September 8, 2017

RE: Initial Submission Review – Saddle Rock East Coffee Shop – GDP
Amdt, PDP Amdt and Site Plan Amdt
Application Number: DA-1216-20
Case Number: 1998-2007-04; 2003-7008-01; 2017-6034-00

STARBUCKS COFFEE COMPANY
LOT 4, BLOCK 1, SADDLE ROCK EAST COMMERCIAL SUBDIVISION FILING NO. 1
COUNTY OF ARAPAHOE, COLORADO
45,295 SQ. FT. (1.040 ACRES)
SITE PLAN

SHEET NUMBER:
8

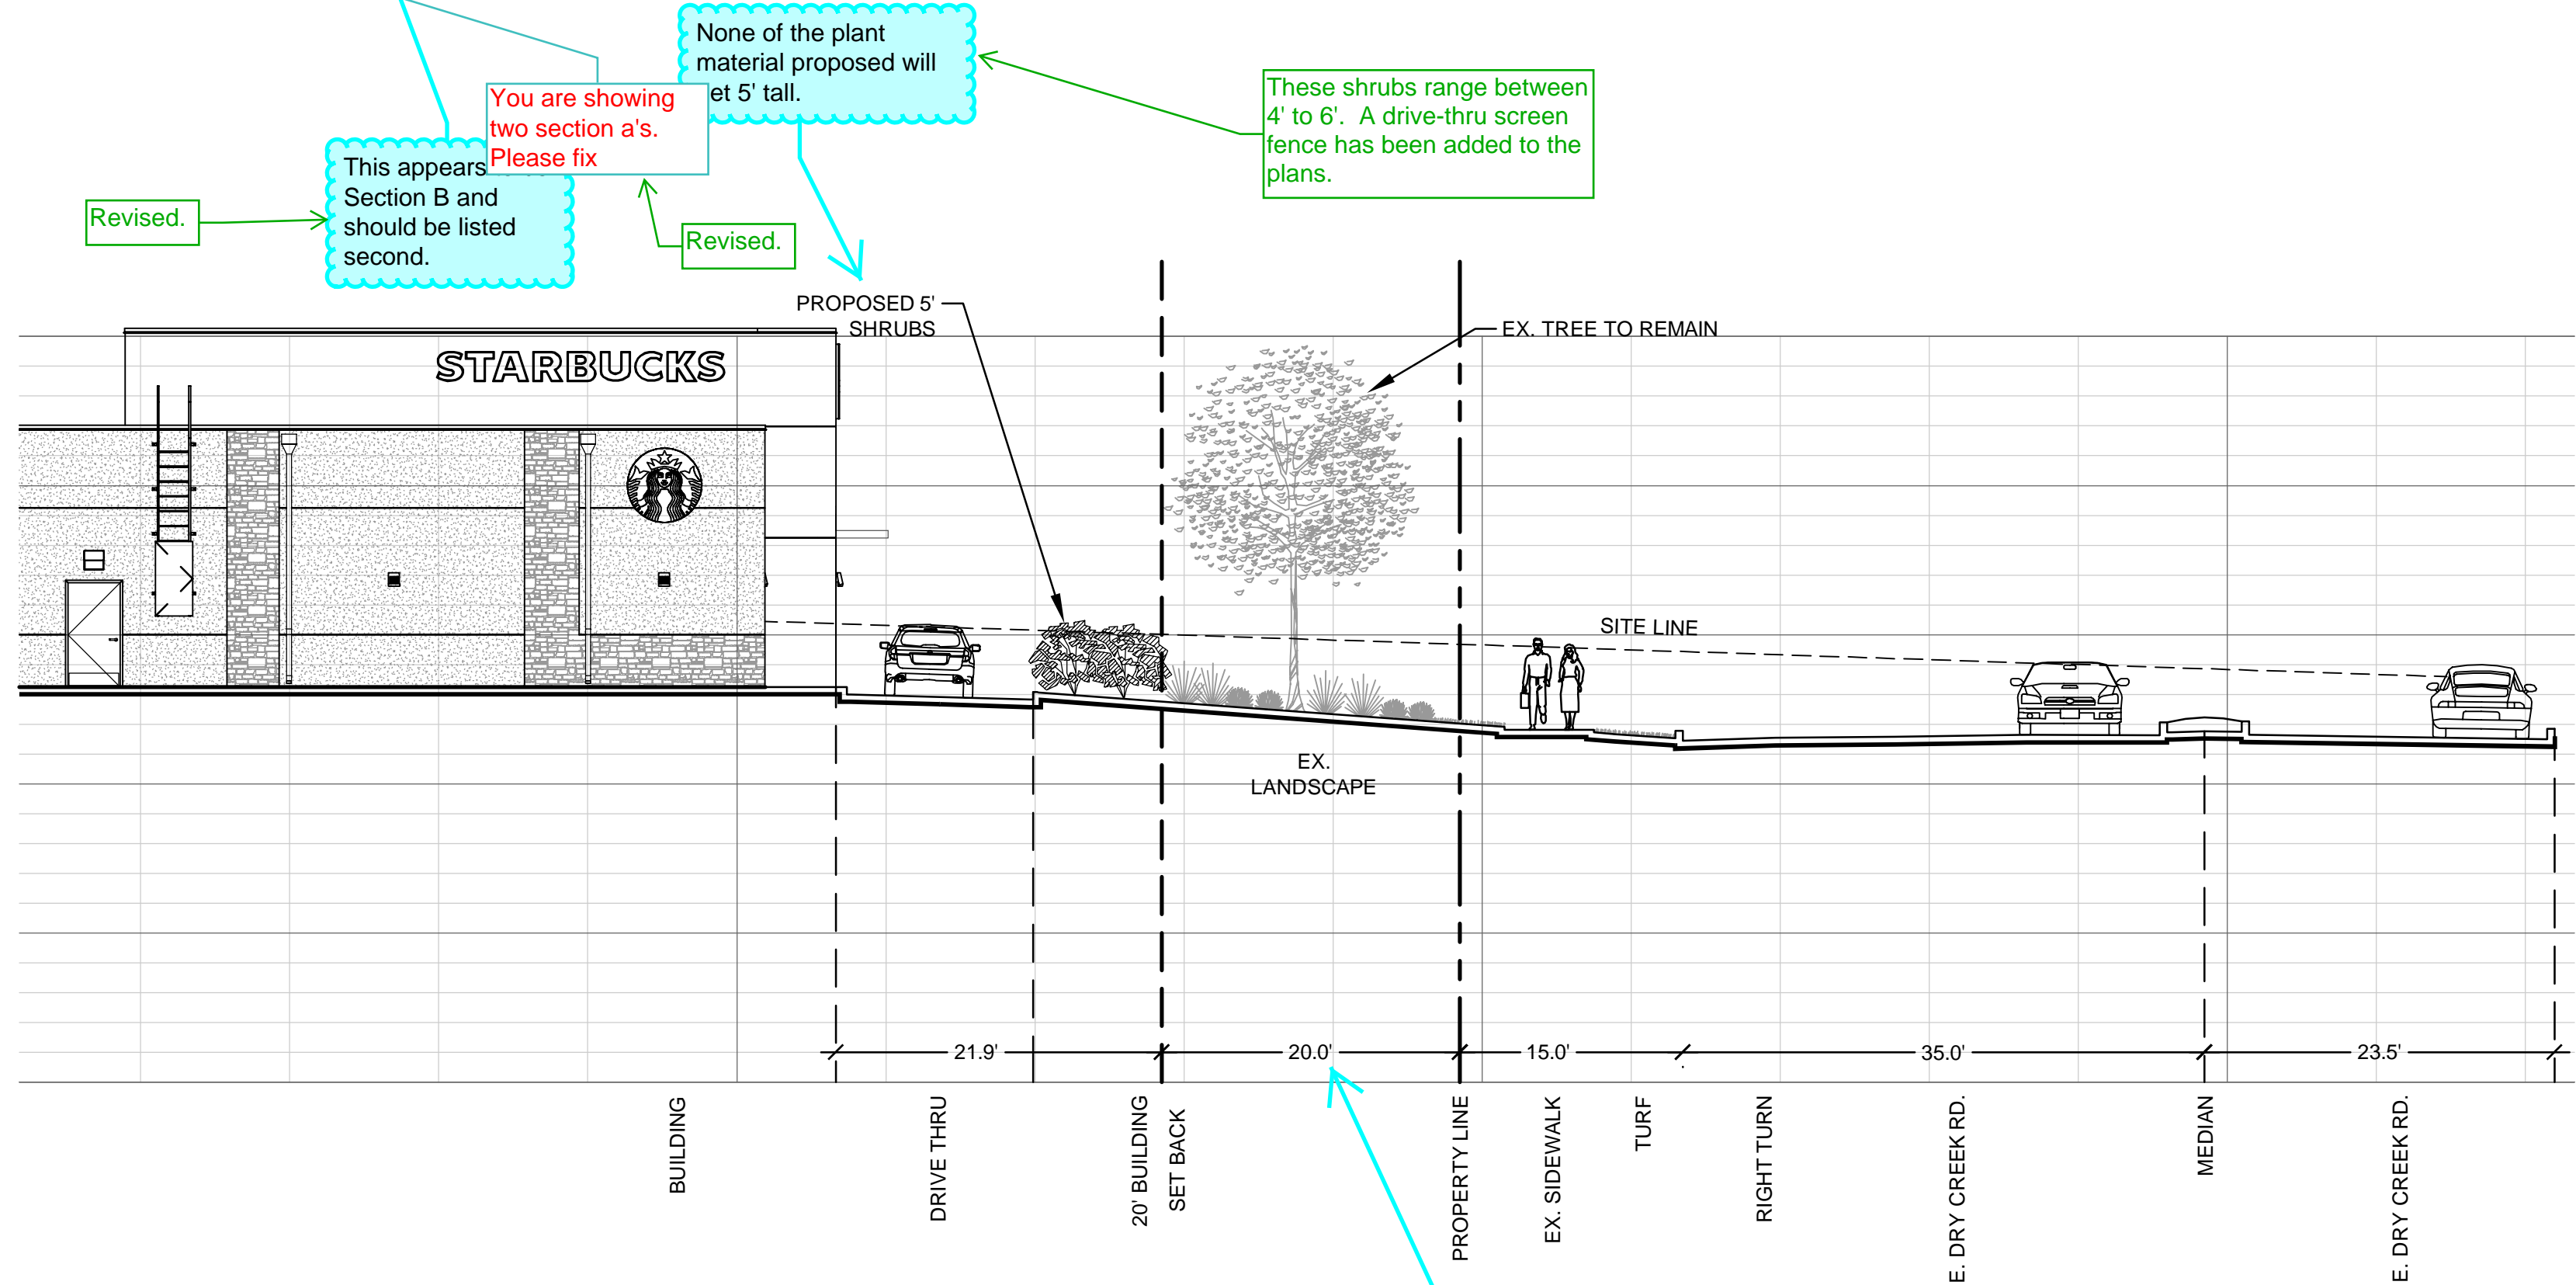
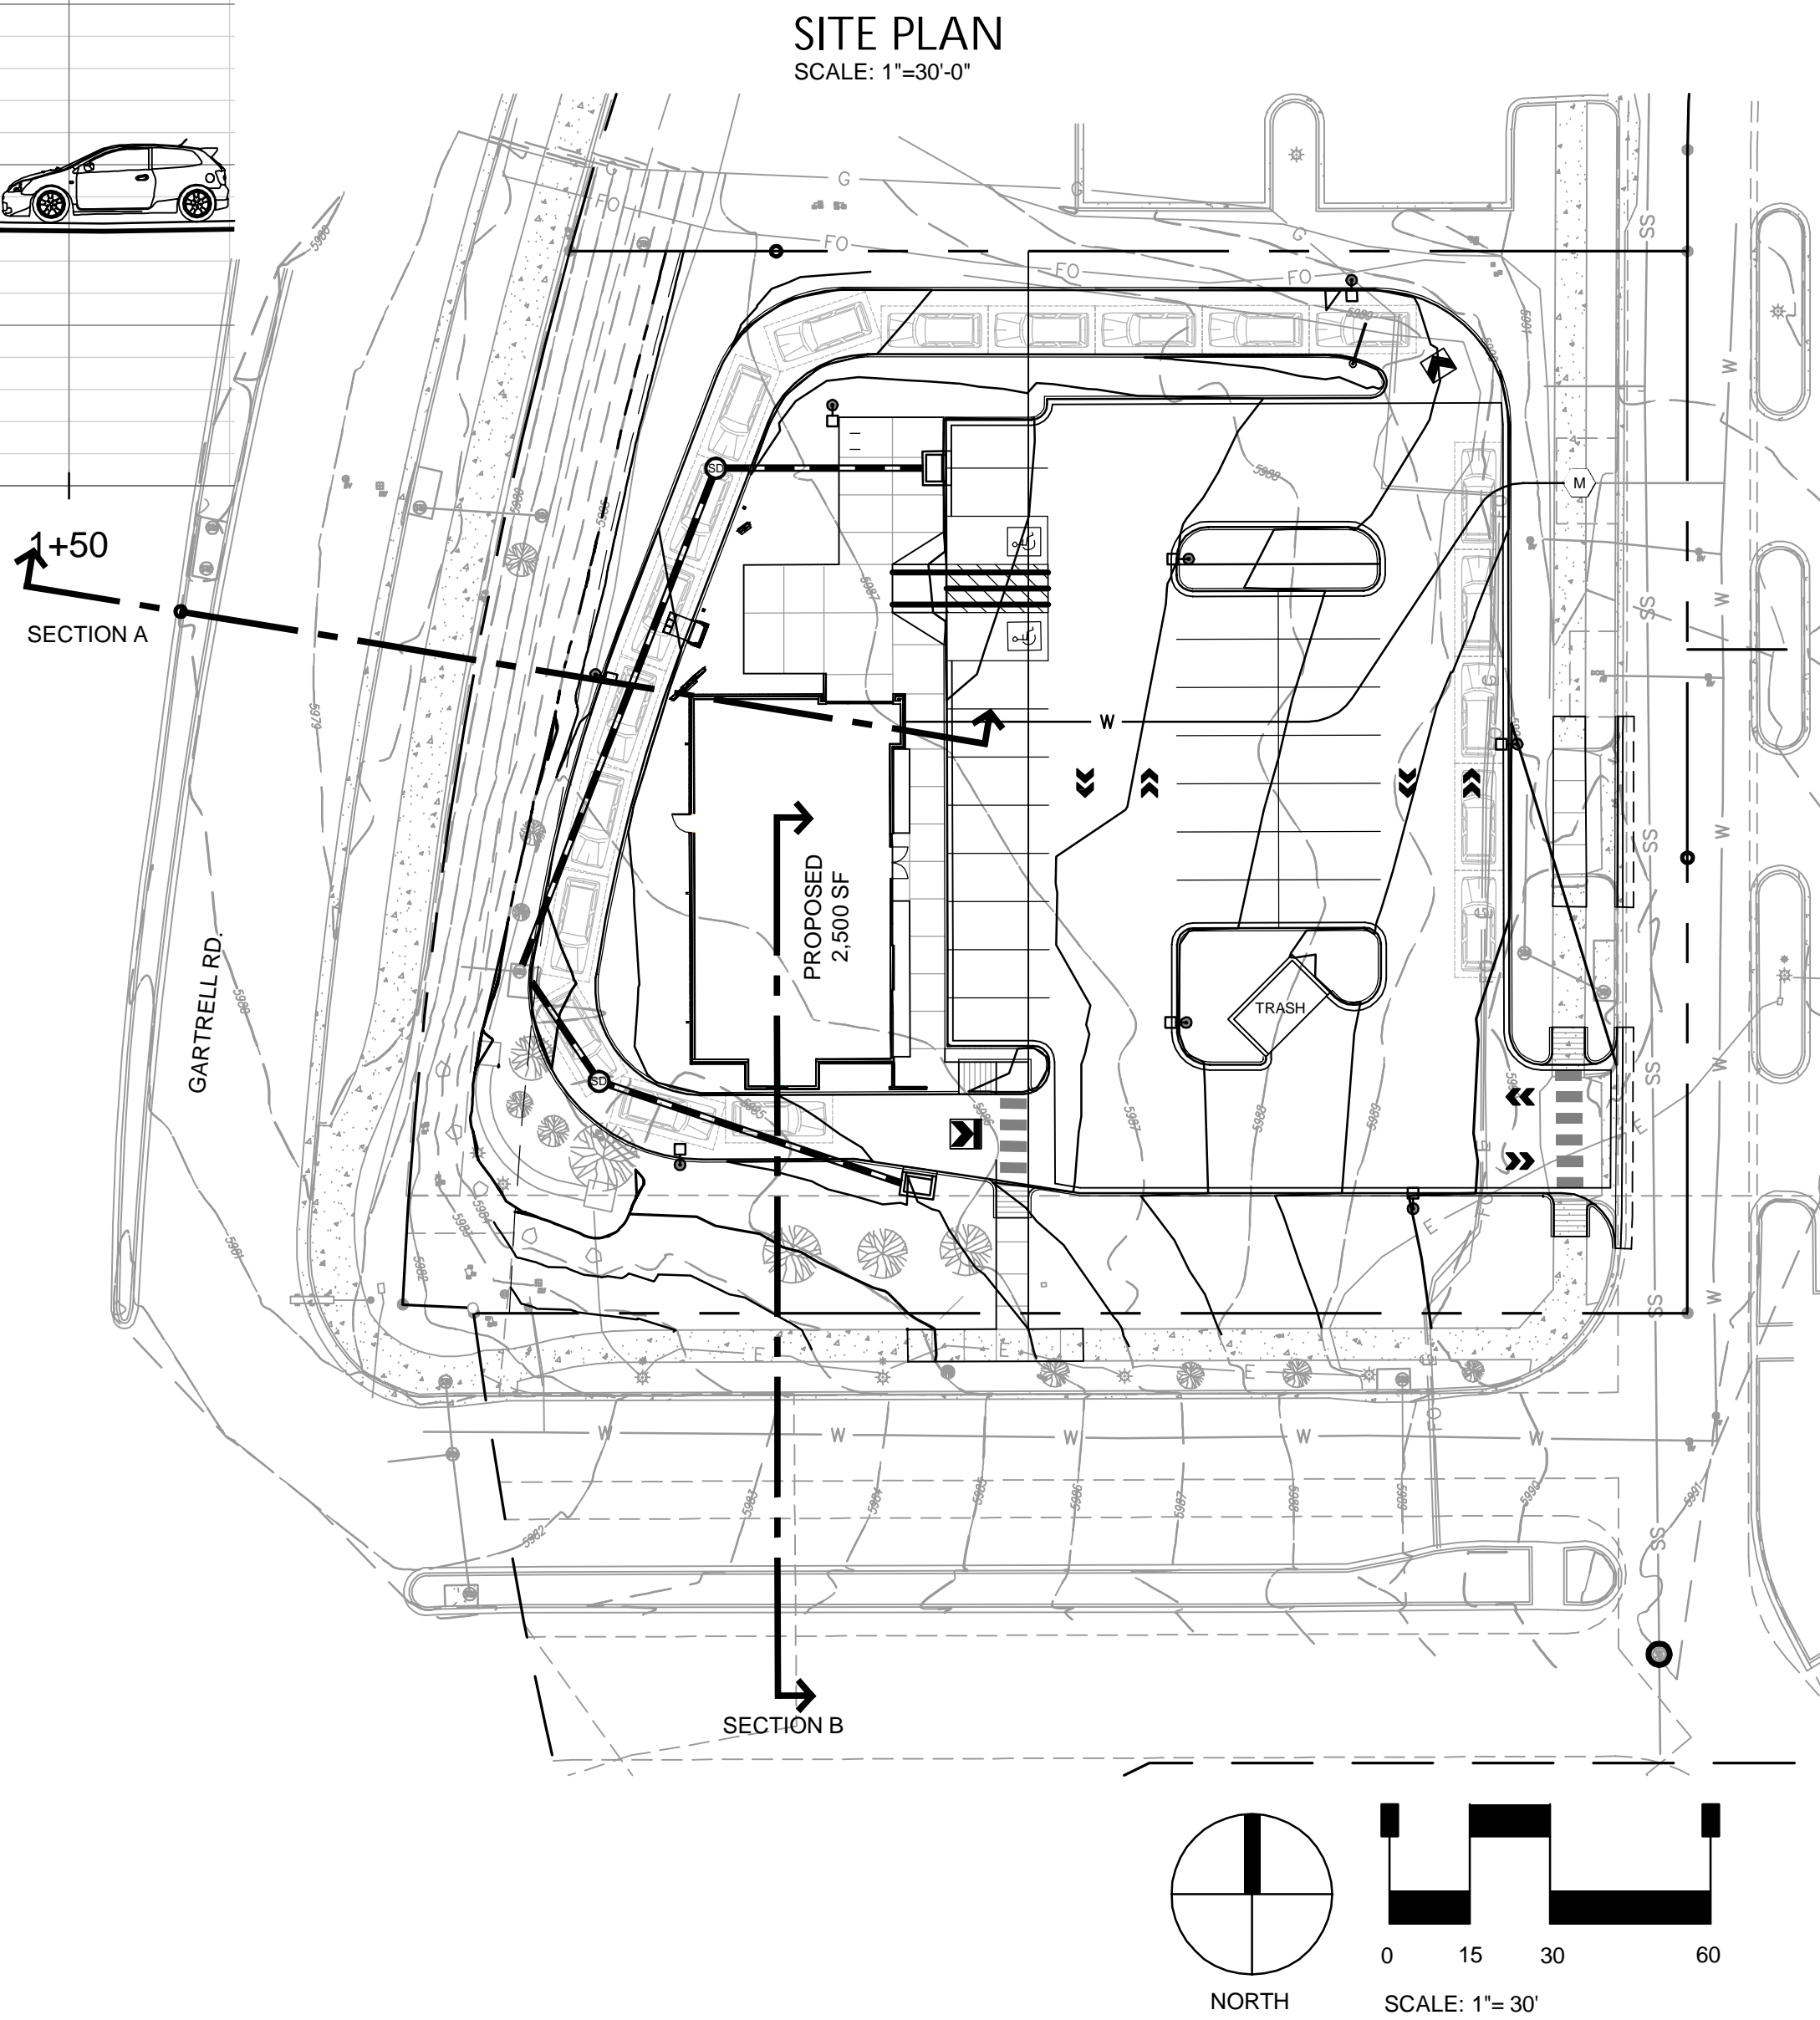
- One of the cross sections needs to be renamed "Section B". Reverse the cross sections as presently shown on the sheet as Section A is shown second and what is to be Section B is shown first. – Section B has been revised and added to the plans.
- The plant material proposed to buffer the drive through lane will not mature to a height of five feet tall. In order to meet screening requirements, please provide a masonry wall adjacent to the drive through lane which matches the predominant building materials of the coffee shop. An adjustment is the site layout will be necessary in order for it to meet the GDP requirements of a

- Both cross sections are labeled as "Section A". Please correct this error. – Revised

1 TRASH ENCLOSURE-

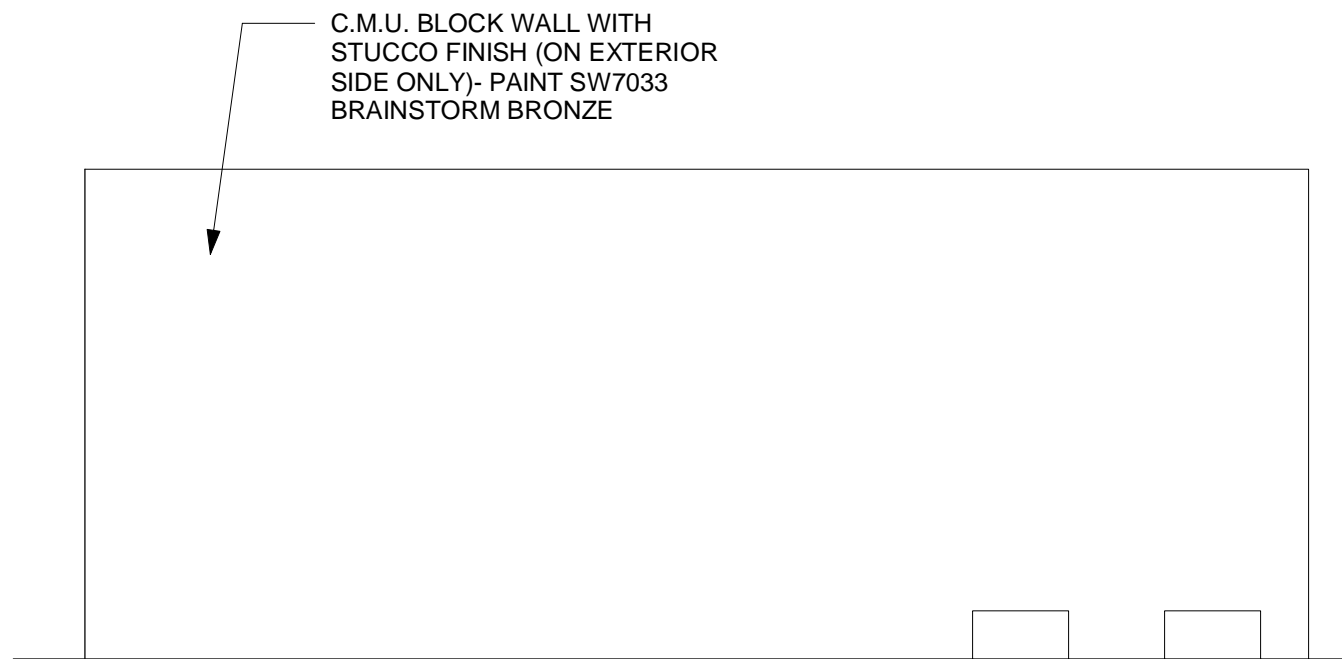
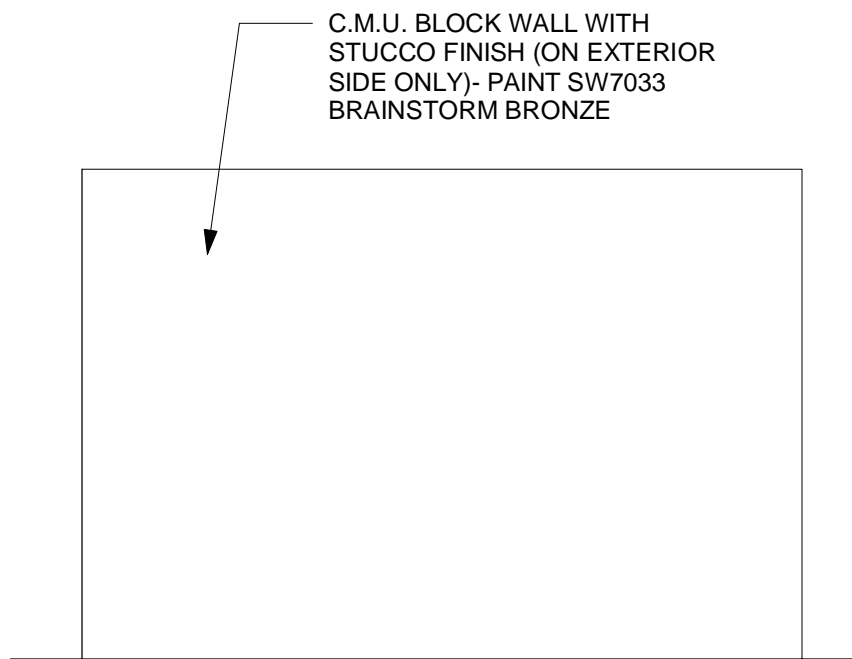
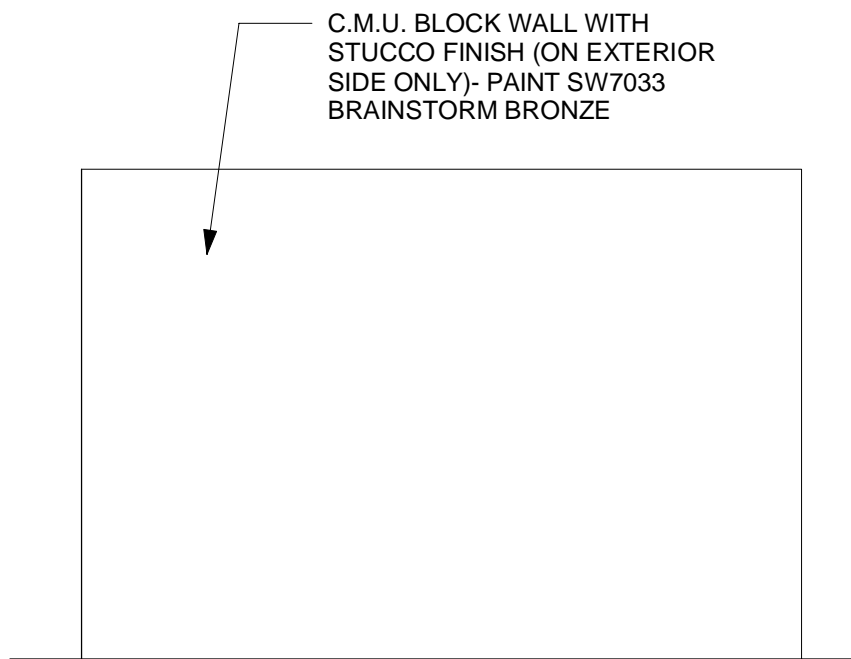
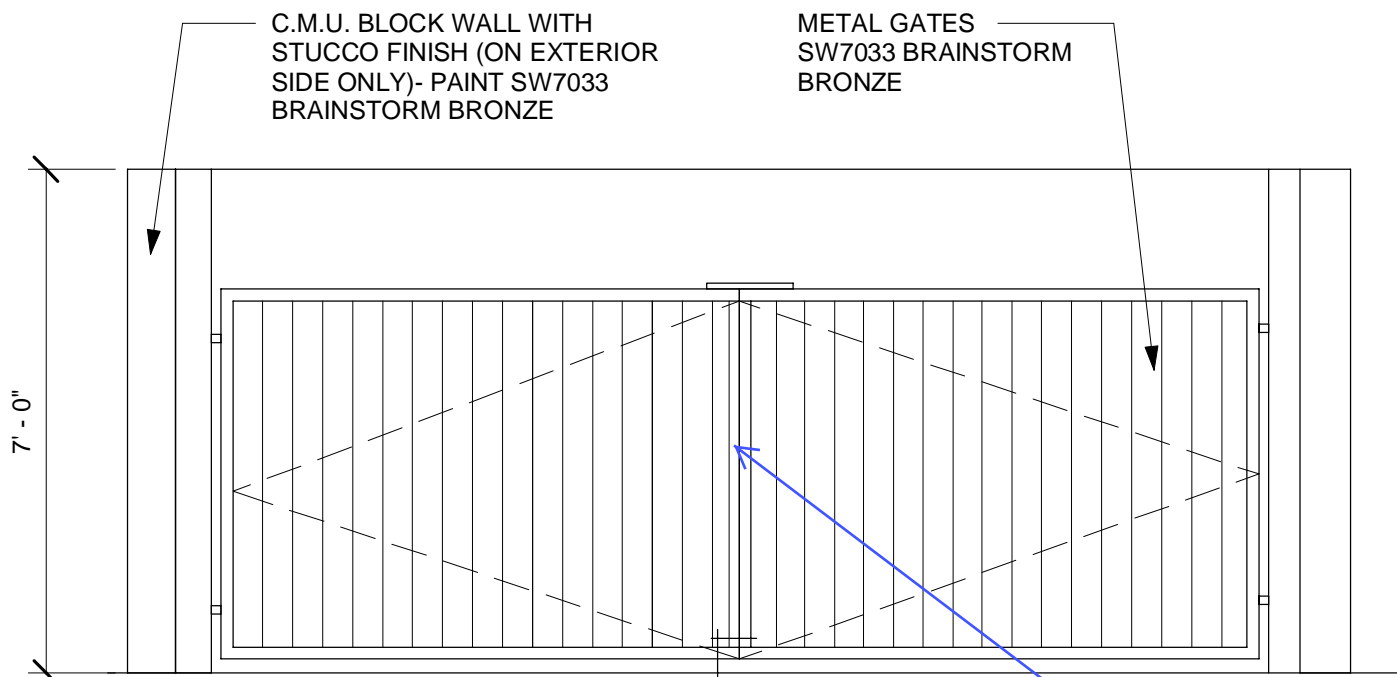
• As per Article 20 of the Zoning Code, "Stucco shall not include any exterior insulation and finish system (EIFS) or synthetic stucco." As per City Code, EIFS may not be counted towards your masonry percentages. Please replace all EIFS building materials with stucco or an approved building material in the PDP.

Show detail of accessibility to trash enclosure. Example: Self closing swinging doors with latch no greater than 44" in height.

Please provide details of proposed trash receptacles, outdoor seating, and benches. These must be consistent with design standards of the Saddle Rock East Commercial (Super Target) CSP
The Existing Starbucks on Lot 2 identified drive through ordering sign details on the site plan. Please include these details on this site plan.

Revised

Revised to match building
